Attachment 1 - PLN19/0221.01 - 142 Johnston Street Fitzroy - Engineering Referral comments

To: Alexandra Paraskevakis
From: Artemis Bacani
Date: 23 April 2021
Subject: Application No: PLN19/0221.01
 Description: Amendment for Gym Use
 Site Address: 142 Johnston Street, Fitzroy

Attachment 5 - PLN19/0221.01 - 142 Johnston Street Fitzroy - S72 Amendment decision plans

Project No.	1901	A102	
Client	OFF THE PLAN INVEST	PROPOSED FLOOR PLAN	
Project	JOHNSTON ST TENANCY 2		
Address	142-144 JOHNSTON ST EUTROX VIC	1:200@A3

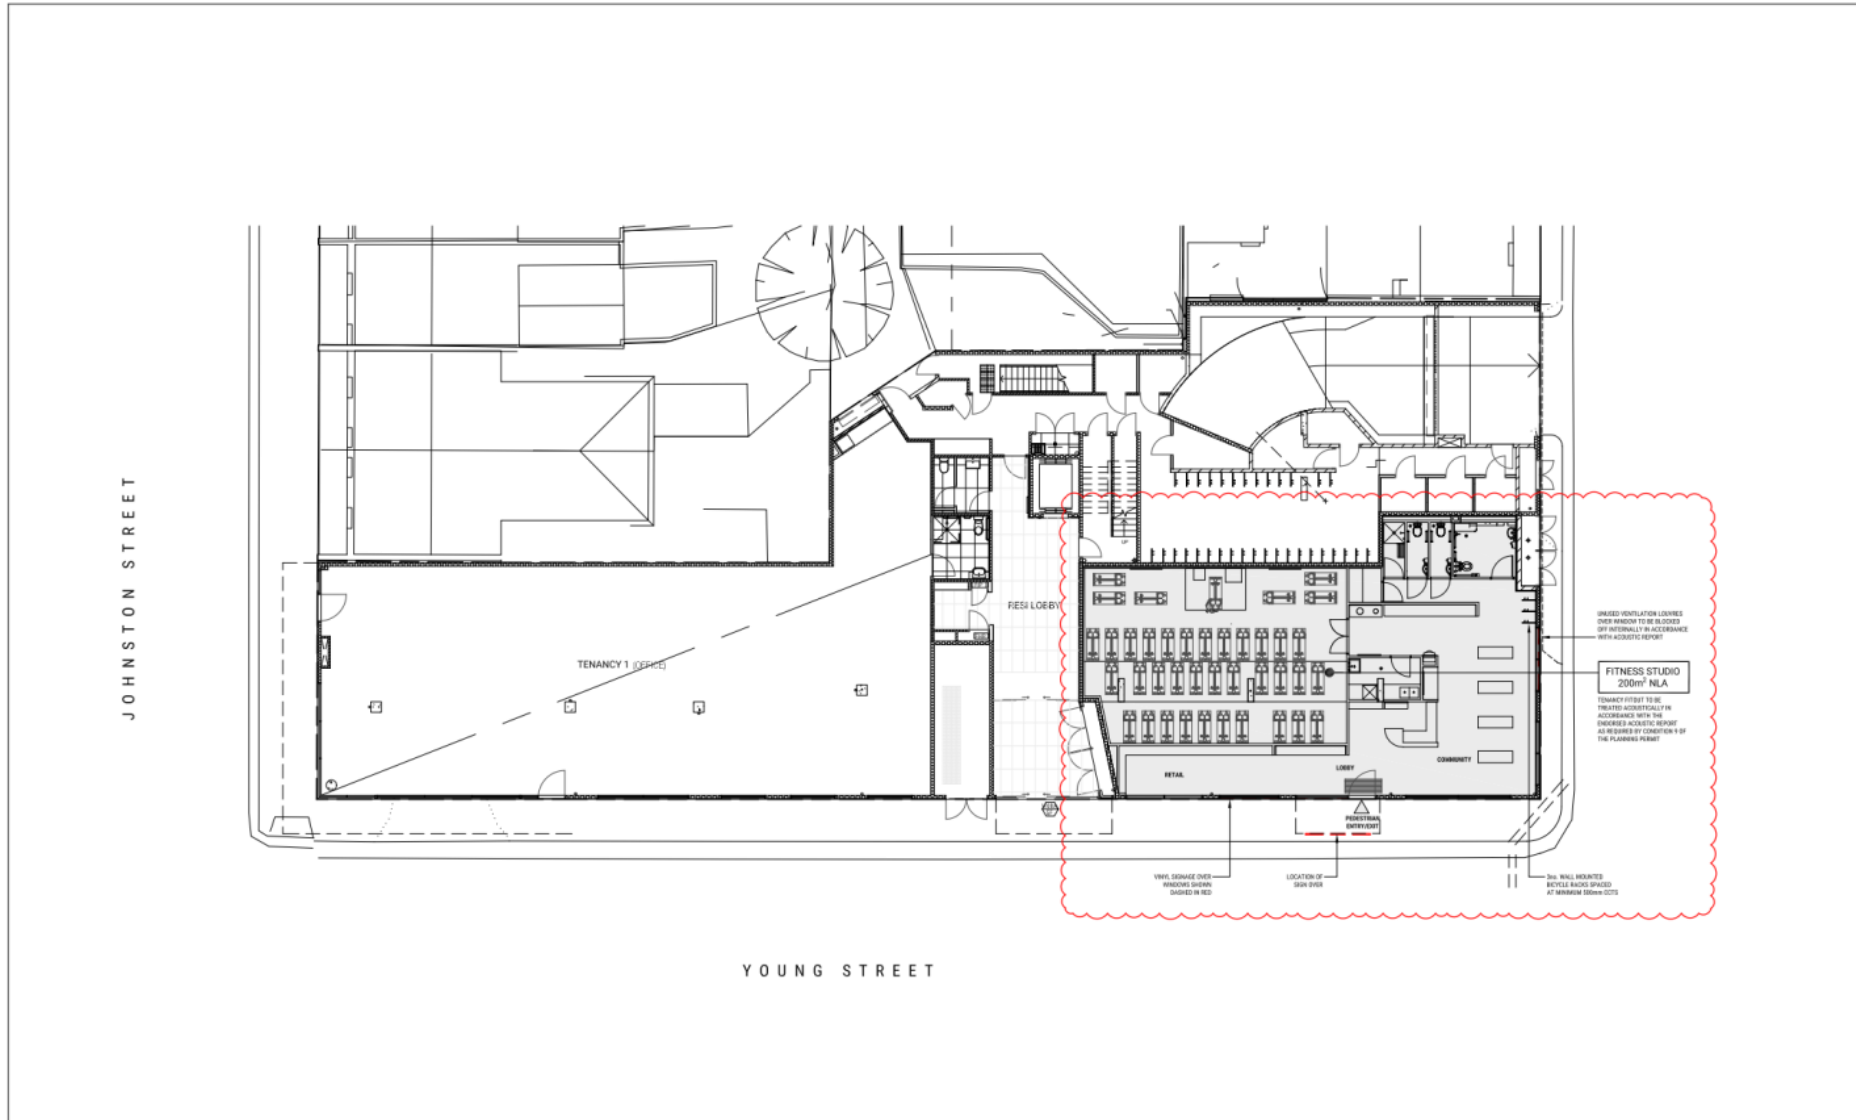
The amendment for Planning Application PLN19/0221.01 proposes an increase in the number of patrons from 12 to 39 – an increase of 27 patrons. The number of staff at the fitness studio will remain at four.

No additional car spaces is proposed within the basement car park.

I've reviewed the amended plans and confirm the revised bicycle parking is acceptable; provision of 3 spaces meets the Statutory requirement, this is based on the assumption that the number of employees is still 4. The layout of bike racks is acceptable and a notation that the racks will be spaced 500mm apart has been included on the plans, as per the permit Condition 1(c).
